**Subject:** 6 Mitchell Road Palm Beach 2108 DA 2021/1596 WRITTEN SUBMISSION:  
LETTER OF OBJECTION Submission: Thomas

SUBMISSION: THOMAS  
a written submission by way of objection to DA 2020/1596

Re:  
6 Mitchell Road Palm Beach 2108  
DA 2021/1596

*the demolition of existing structures and construction of a new four-storey dwelling and associated works at 6 Mitchell Road, Palm Beach.*

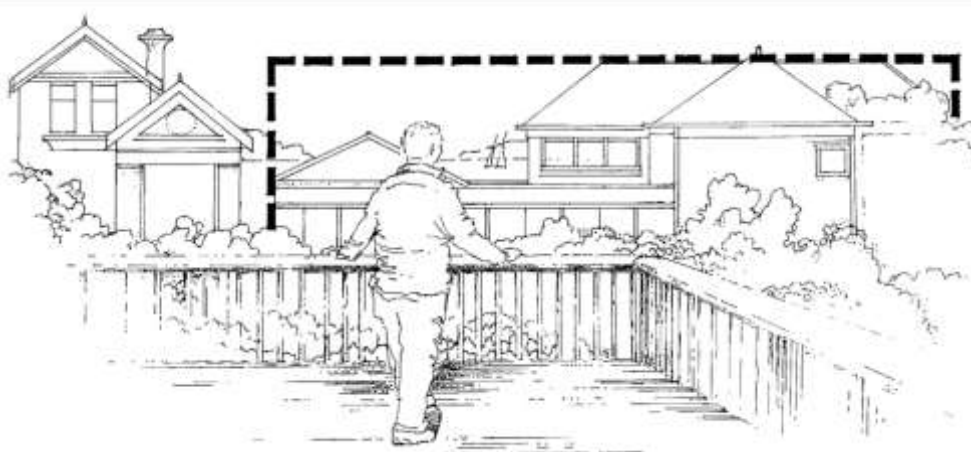
#### Step 4: Reasonableness

The planning principle states that consideration should be given to the causes of the visual impact and whether they are reasonable in the circumstances.

Having applied the tests in the Tenacity planning principle and without height poles erected, we conclude that we would be exposed to a moderate view loss.

The non-compliance with planning outcomes and controls of the proposed development causes this loss.

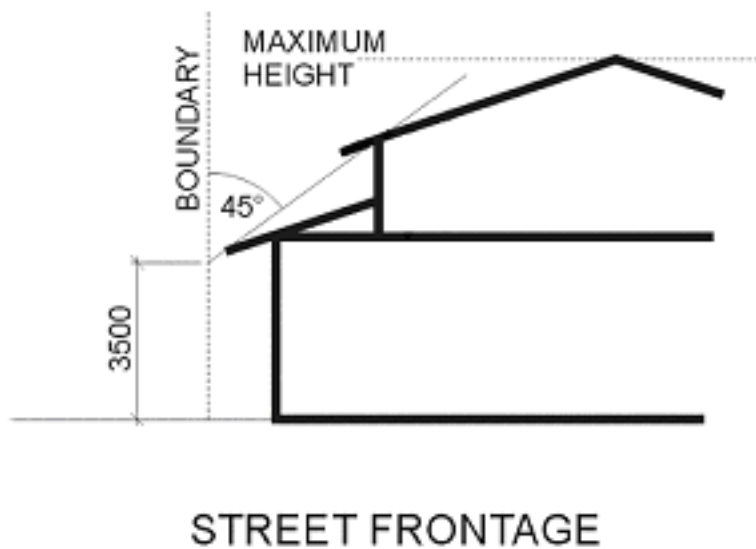
*The bulk and scale of the built form is minimised. (En, S)*

*Equitable preservation of views and vistas to and/or from public/private places. (S)*

*To ensure a reasonable level of privacy, amenity and solar access is provided within the development site and maintained to neighbouring properties. (En, S)*

The total landscaped area on land zoned R2 Low Density Residential or E4 Environmental Living shall be 60% of the site area. The provision, with compliance to correct measurement and calculation, would result in a major non-compliance to this main density control.
